NL-13-1177

Vogtle Electric Generating Plant – Units 1 and 2
Supplemental Response to NRC Request for Additional Information for License
Amendment Request to Revise
Technical Specification 3.7.9 Ultimate Heat Sink (UHS)

Response to Supplemental Questions

**Calculation X4C1202V70, Version 4
NSCW Cooling Tower – Operation With One Fan Out of Service At Low
Ambient Wet Bulb Temperature**

Figure Add-1 plots the change of the maximum allowable wet-bulb temperatures corresponding to a range of initial basin temperatures between 65 to 90°F. The main body (MB) part 2 wet bulb temperature result of 63 °F is also plotted for comparison purposes.

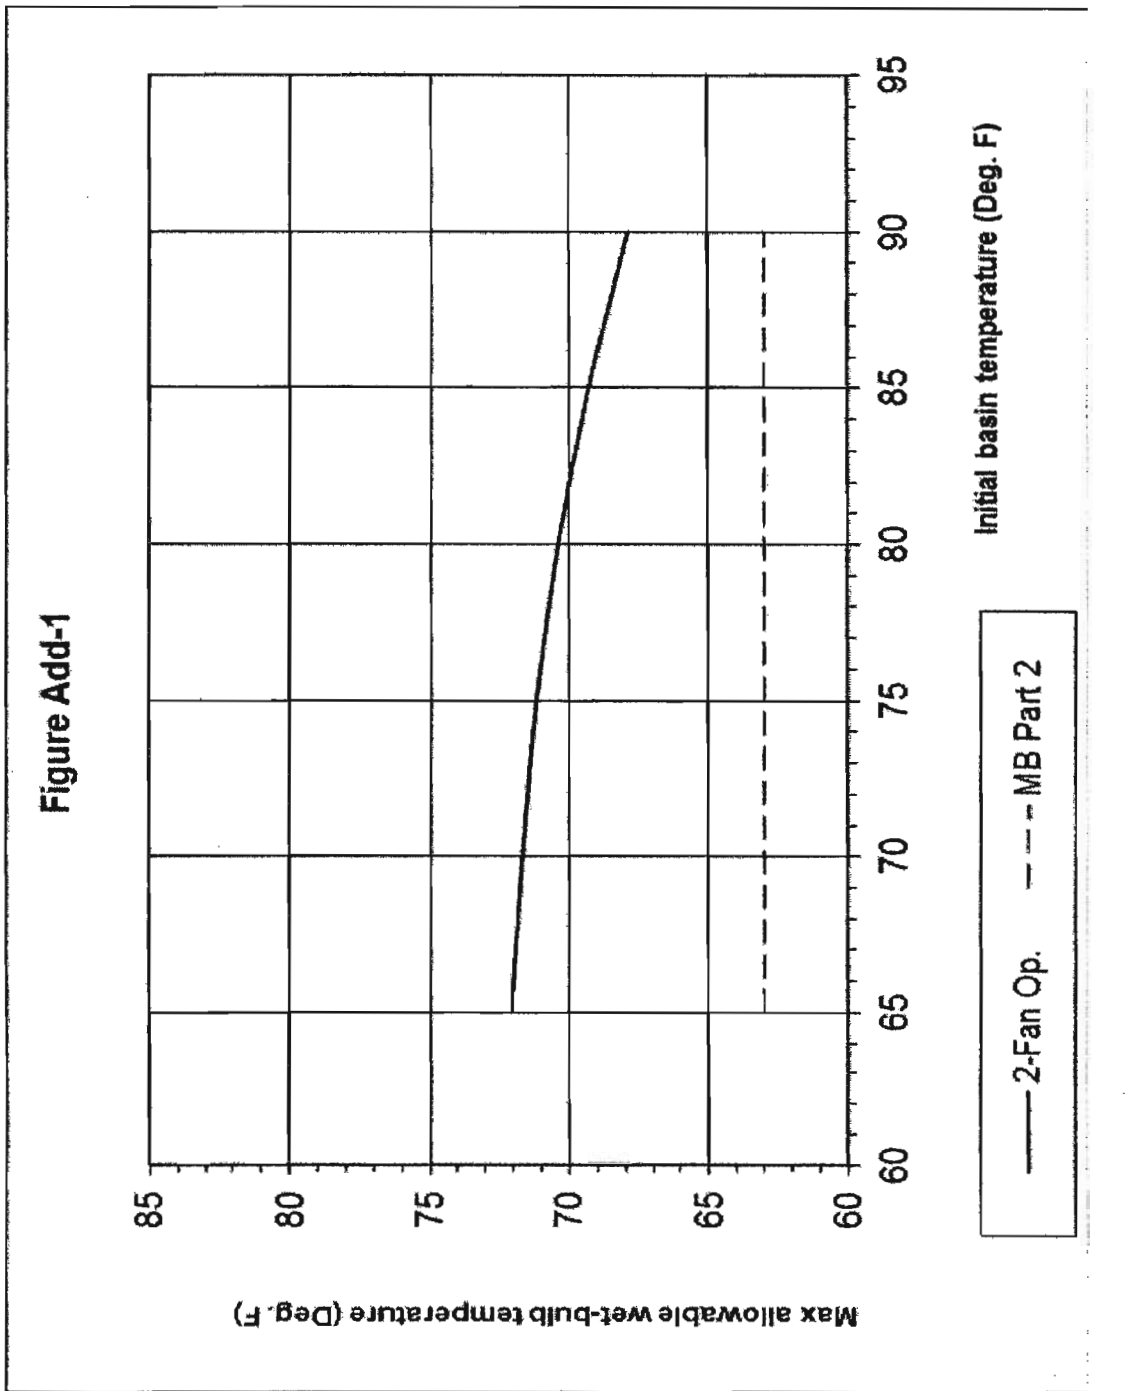
1. In response to RAI-2 dated February 17, 2013, the licensee stated that their analysis does not need to consider the first 4 hours after a loss of offsite power (LOSP) event because of a net reduction in total NSCW heat and the reduction of basin temperature during the first 4 hours after the LOSP. Their conclusion was based on their calculations which show an 80% reduction in auxiliary component cooling water (ACCW) heat load from normal operations to no load at hot shutdown with a LOSP. They further stated that the ACCW reduction is greater than the heat load of the diesel generator (DG) added at LOSP. From Table 9.2.2-1 of the FSAR, the staff notes that an 80% reduction in ACCW load is about 19.5 MBTU/hr and that the addition of the DG adds about 17.1 MBTU/hr to the NSCS heat load yielding a small net decrease of 2.4 MBTU/hr.

However, the staff also notes that at the same time of LOSP, the operable cooling tower loses one fan from a tornado missile yielding 2 fans operable instead 3 fans operable. This fan reduction causes approximately a 33% reduction in cooling tower ability to remove heat energy from NSCW. Therefore, how can the licensee say that there will be a reduction in basin temperature during the first 4 hours after a LOSP and that the first 4 hours does not need to be considered? Please explain.

As a result, calculation X4C1202V70 has been updated to consider the NSCW heat load during the first 4 hours with a reduction of two fans accounted for at the beginning of the LOSP event. This latest version of the calculation (version 4) adds a section in Addendum 1 that determines the total NSCW heat load for 0 to 4 hours. The heat loads determined do not include the RHR heat loads and are, therefore, significantly lower than the peak heat load after the fourth hour. The heat load profile developed includes the heat load due to the start of the diesel generators, auxiliary component cooling water loads that decrease with the reduction in RCS

The results of this re-analysis, where two out of four fans are out of service due to one fan removed from service and an additional fan lost due to a tornado missile, reduces the maximum allowable wet bulb temperature as much as 0.6 °F (when compared to the February 27, 2013 response) for all initial basin temperatures analyzed, except for the 90 °F initial basin temperature. The maximum wet bulb temperature at 90 °F initial basin temperature was increased by 1.1 °F (when compared to the February 27, 2013 response) due to the performance characteristics of the cooling tower fans, (i.e., the performance of the cooling tower fans improve at higher NSCW temperatures). See Addendum 1, Section 5.0 of Enclosure 2 for more details.

Figure Add-1 determines the maximum allowable wet bulb temperature for a range of initial basin temperatures for cases in which the peak basin temperature stays below 97 °F. This addendum still uses conservative assumptions and increased heat loads for MUR. The improvement for this 2-fan tower operation case as compared to wet bulb temperature result in part 2 of main body are due to:
